MEMORANDUM TO: John A. Grobe, Chairman  
Manual Chapter 0350 Panel for D.C. Cook

SUBJECT: RESOLUTION OF DEGRADED CEQ FAN ROOM WALL

Discussion of Containment  
Subcompartment Walls

Restarting D. C. Cook  
June 1, 2000

# **Description of the Issues: Grout Strength**

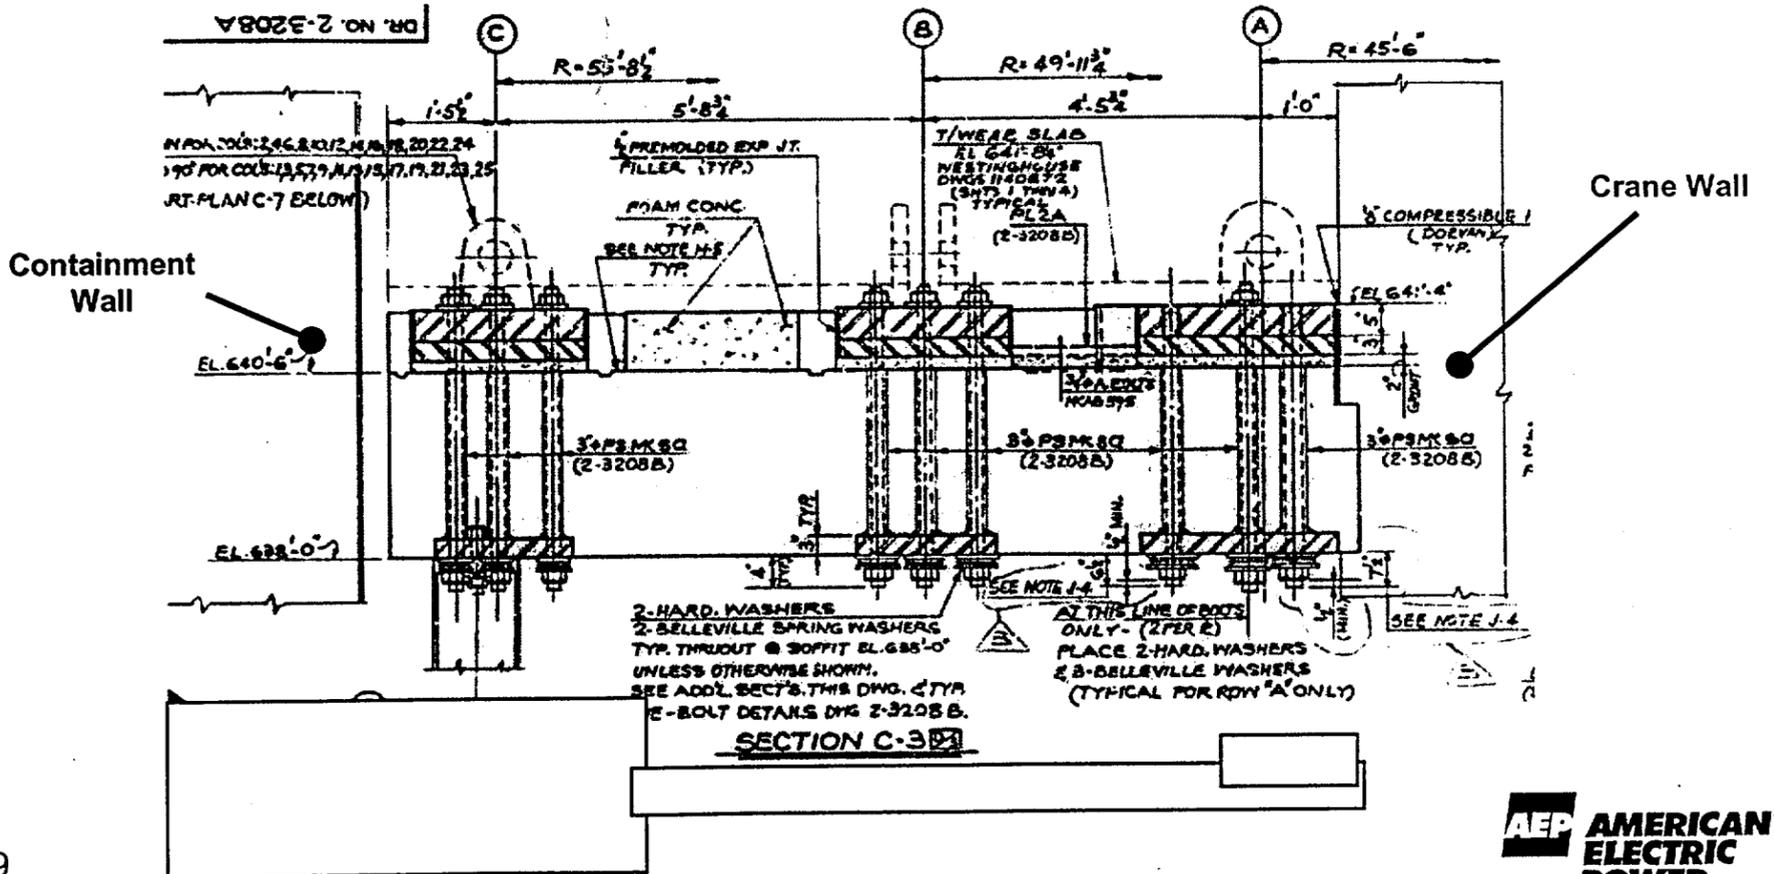
- **Spalling Discovered During System Readiness Reviews**
  - Grout discovered during repair
- **Top of 126° and 307° Walls Grouted**
  - 126° wall due to ice condenser structure interference
  - 307° wall due to construction sequence - installed after ice condenser slab poured
- **Grout Strength**
  - Estimated as 1000 psi in 126° wall
  - Tested in 307° wall: 1,280, 1,770, and 4,380 psi

# Analysis: Results

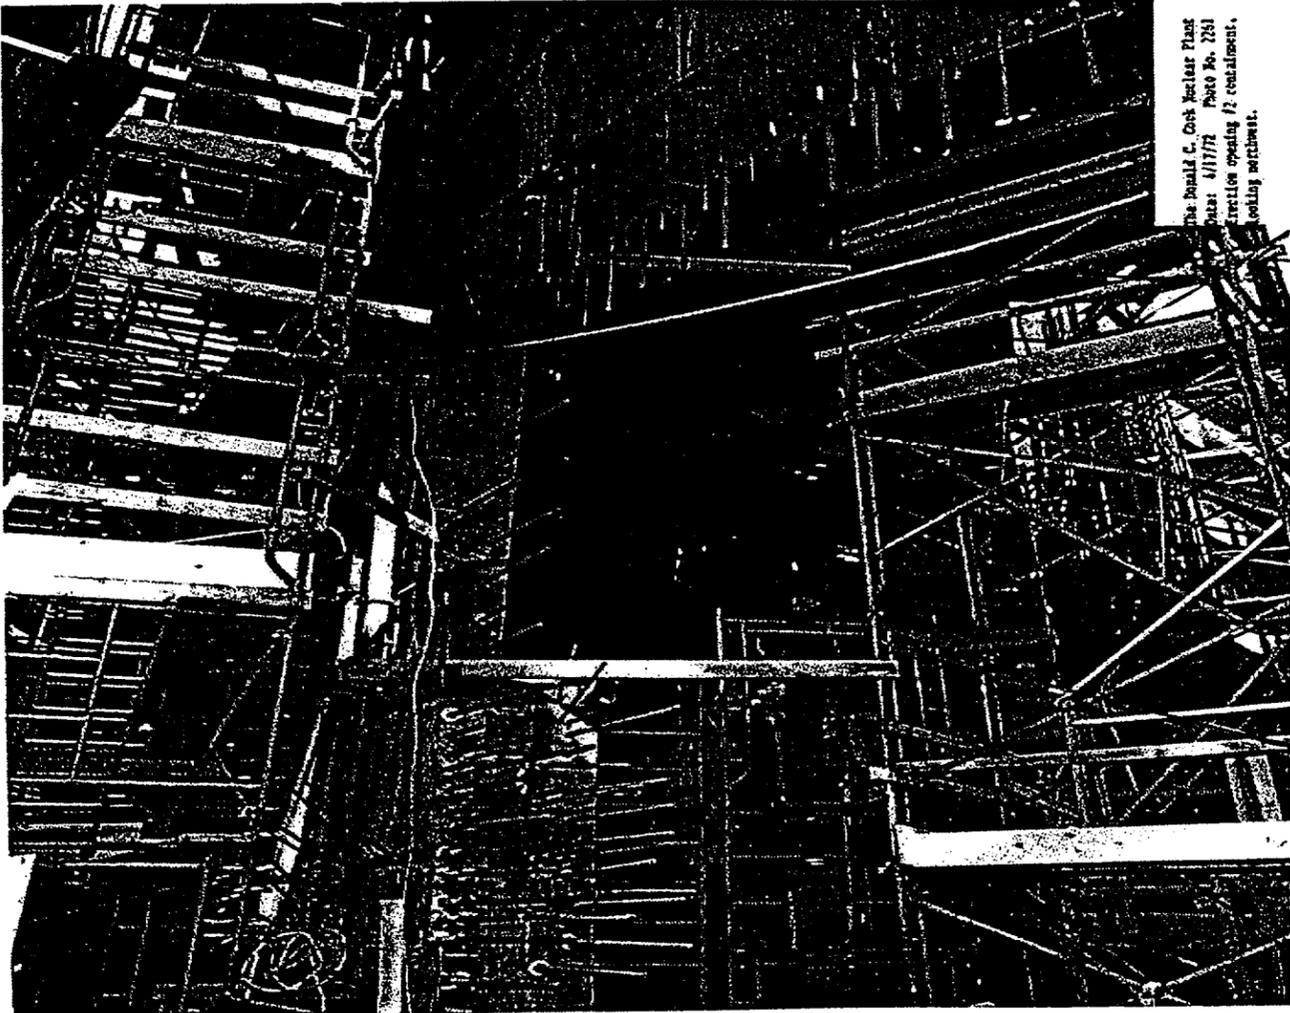
- Conservative Analysis
- All Four Walls Operable
- Margin Available ( $C > 1.0$  P1)

<u>Wall</u>	<u>Simplified</u>	<u>Yield Line</u>
54°	1.36	1.48
126°	1.21	1.34
234°	1.25	1.54
307°	1.29	2.83
